Access Compliance Report Public Rights-of-Way (Curb Ramps)

Main Street: BOLSA_AVE Cross Street: NEWLAND_ST Location: NW

ADA ID: RPRK220203140509 Ramp Type: Type 4 - Parallel Initial Pass/Fail: Fail Overall Compliance: No Severity Score: 15

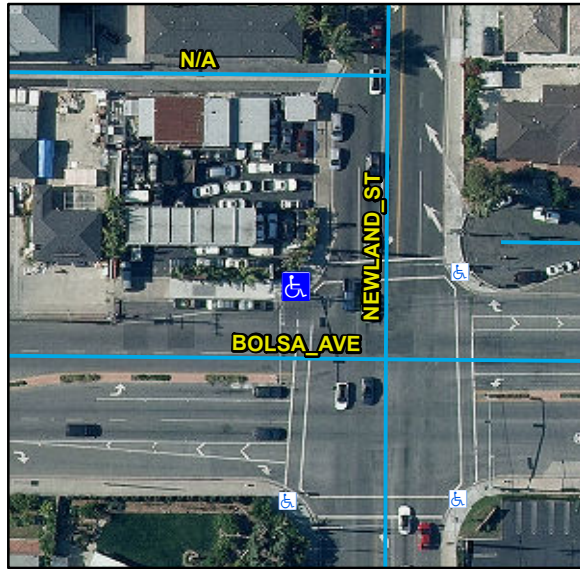
Compliance	Description	Data	Compliance	Description	Data
N/A	Ramp Length LT (in)	84	N/A	Ramp Length RT (in)	93
Yes	Ramp Width LT (in)	110	Yes	Ramp Width RT (in)	110
Yes	Ramp Run Slope LT (%)	6.1	Yes	Ramp Run Slope RT (%)	5.6
No	Ramp Cross Slope LT (%)	5.8	No	Ramp Cross Slope RT (%)	3.3
N/A	Landing Present	N/A	N/A	DWS Provided	N/A
N/A	Landing Length (in)	N/A	N/A	DWS Contrast	N/A
N/A	Landing Width (in)	N/A	N/A	DWS Length (in)	N/A
N/A	Landing Run Slope (%)	N/A	N/A	DWS Full Width	N/A
N/A	Landing Cross Slope (%)	N/A		DWS Offset Type	N/A
N/A	Landing Movement Obstructed?	N/A	N/A	DWS Offset Left (in)	N/A
	Landing Movement Type	N/A	N/A	DWS Offset Right (in)	N/A
N/A	Landing Shared	N/A			
N/A	Clear Space	Yes			
N/A	Clear Space To Crosswalk (in)	48			
N/A	Marked Crosswalk 1	Yes	N/A	Marked Crosswalk 2	Yes
	Crossing 1 Direction	S		Crossing 2 Direction	E
	Marked Crosswalk 1 Width (in)	144		Marked Crosswalk 2 Width (in)	144

N/A	Ramp Inside Crosswalk 1	Yes	N/A	Ramp Inside Crosswalk 2	Yes
	Crossing 1 Slope (%)	5.5		Crossing 2 Slope (%)	5.4
	Crossing 1 Cross Slope (%)	0.7		Crossing 2 Cross Slope (%)	2.2
N/A	Gutter Ponding	N/A	N/A	Curb Slope	8.4
Yes	Gutter Lip Height (in)	0		Road Run Slope (%)	0
N/A	Gutter Run Slope (%)	N/A		Road Cross Slope (%)	5.9
N/A	Gutter Cross Slope (%)	N/A	Yes	Perpendicular Joint Present	Yes
Yes	Overall Surface Condition	Acceptable			
	Cross Gutter Present?	No		Spandrel Present?	No
	Replace Cross Gutter?	N/A		Replace Spandrel?	N/A

Remove & Replace Curb Ramp With Two New Directional Ramps or Equivalent.

R304.5.3, STD 1115
